## William Howard Taft Memorial Bridge Pedestrian Railing Improvement

**Presented to:** Commission of Fine Arts (CFA)  
Jan. 18, 2024

## WHAT WE HEARD FROM THE APPROVAL AGENCIES ON OPTION 3B

Metal Railing

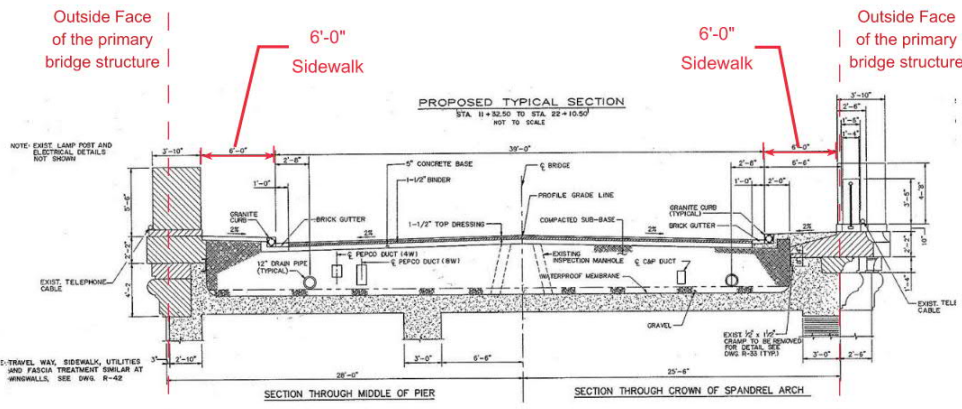
- The top rail may be too slim when it is at 8'-0" feet.
- Pickets are thin and the gap in between should be evaluated.

### 3 - ARTICULATED MASSING VARIATIONS

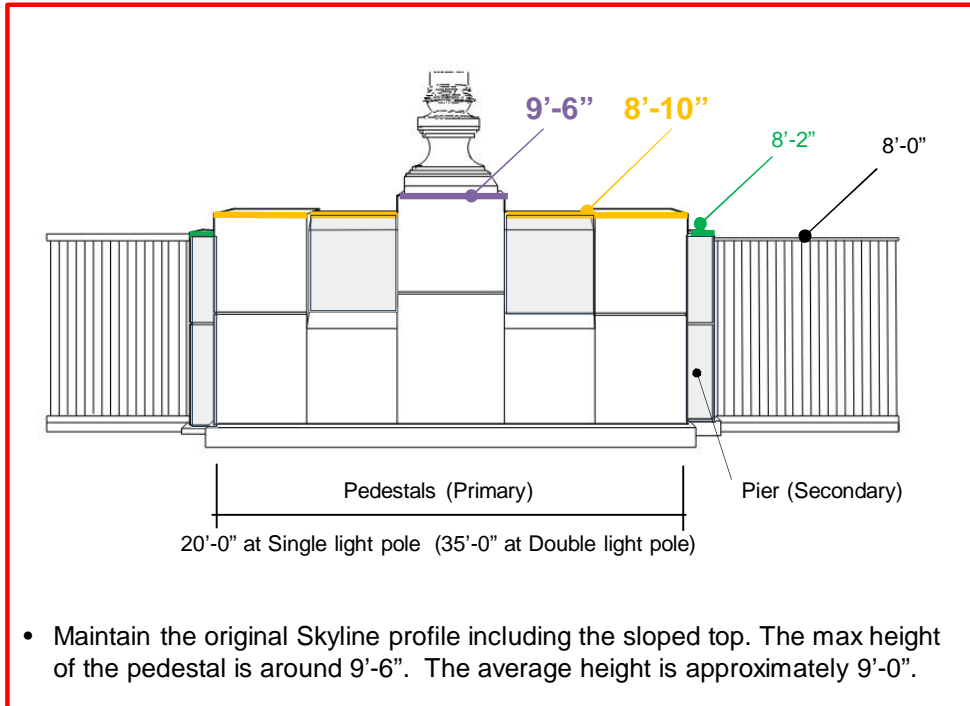
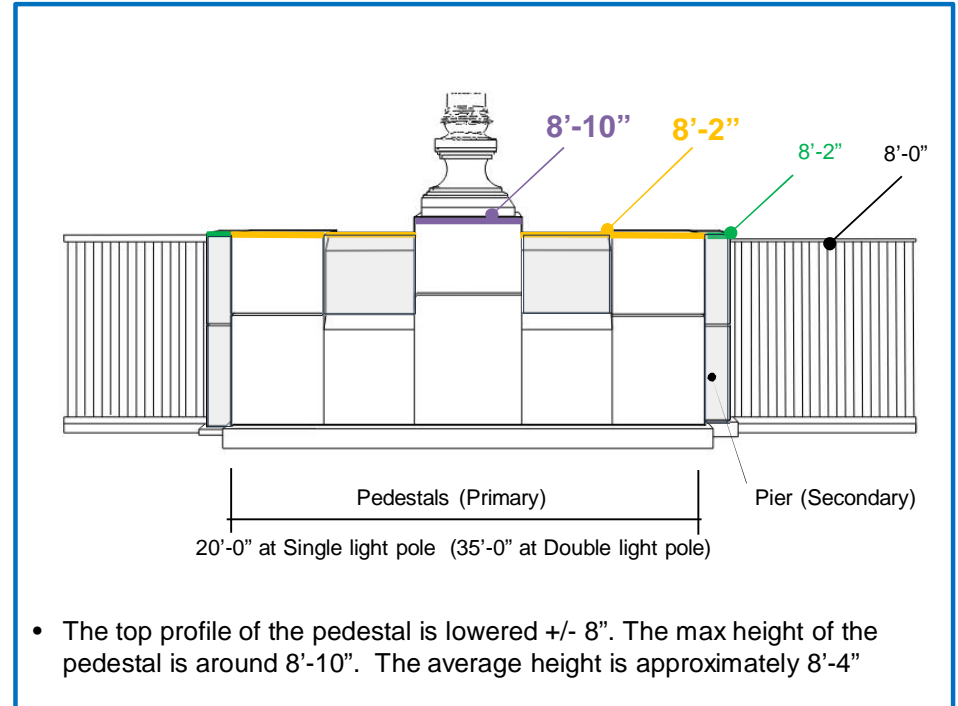
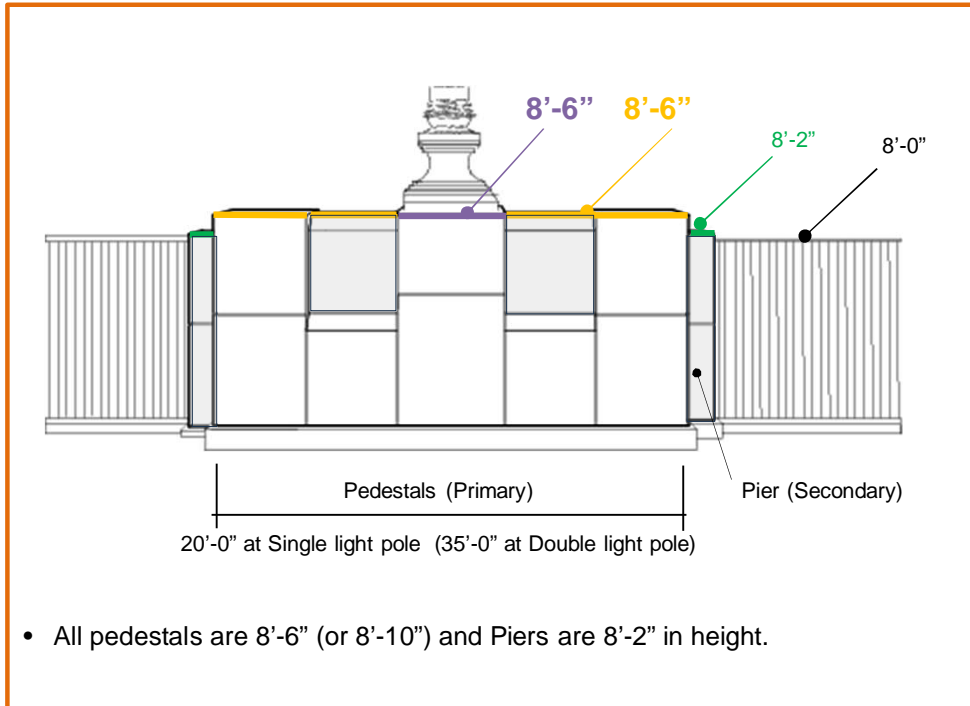
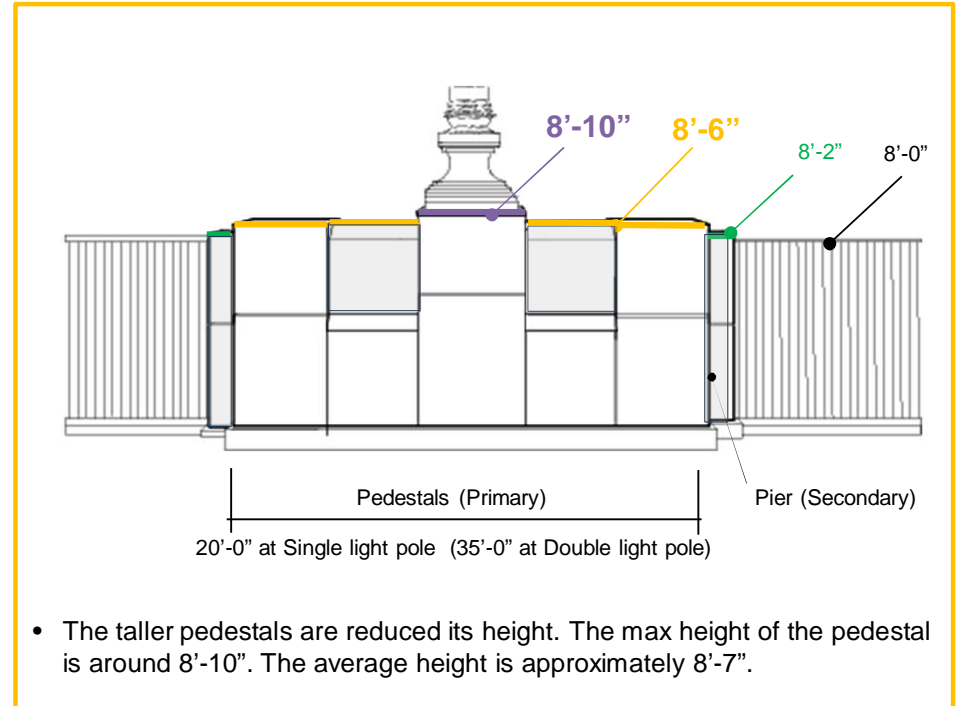
- Option 3B design achieves harmonious and preferred design among other Option 3 variations.
- Lower pedestal height to be investigated.

- Flat and slope tops remain in the design to respect the current design.
- Articulated 4" setback applied upper portion of the selected mass
- 60 degrees steep slope transition at the bottom of the recessed surface to avoid foot and handholds

**Post**

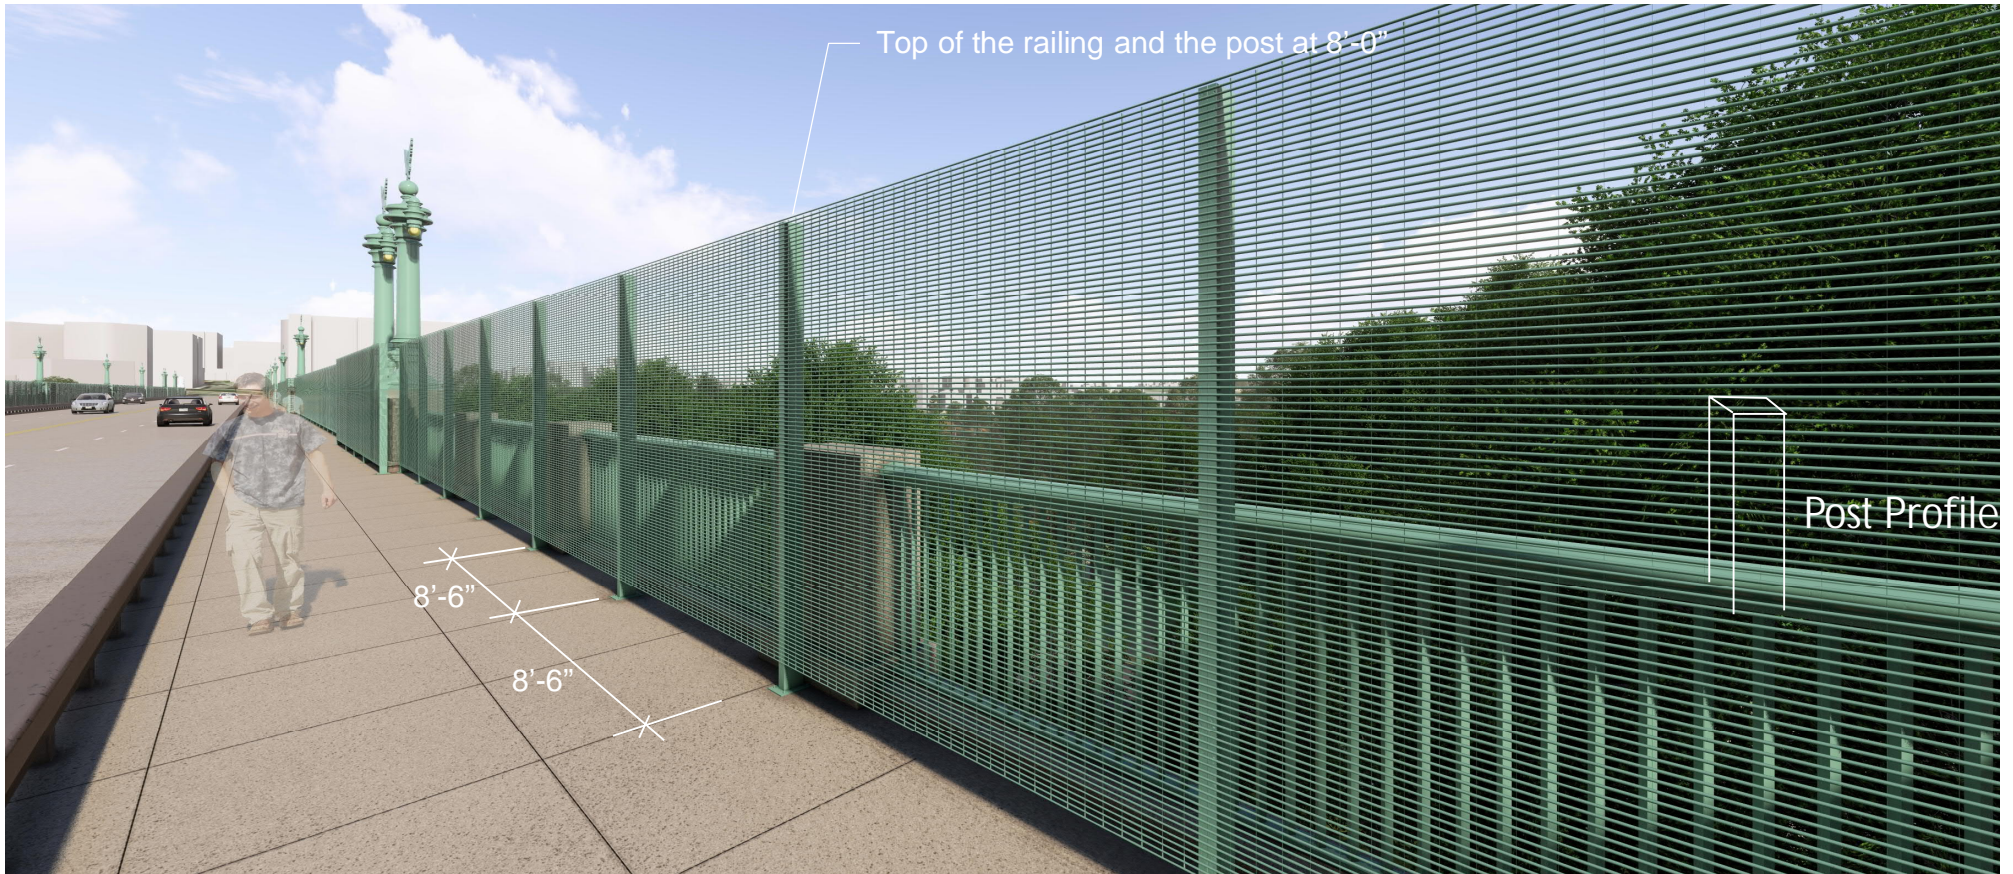
- This is a back option only if Option 3B is not accomplished.
- This additive & industrial-look design is not preferred.

- Wire mesh opening and spacing.
- Additional view of Close-up Wire mesh is preferred

- Temporary look of the post is not preferred.
- What is the optimized post spacing? The design team should evaluate the size of the post and the spacing of the post.
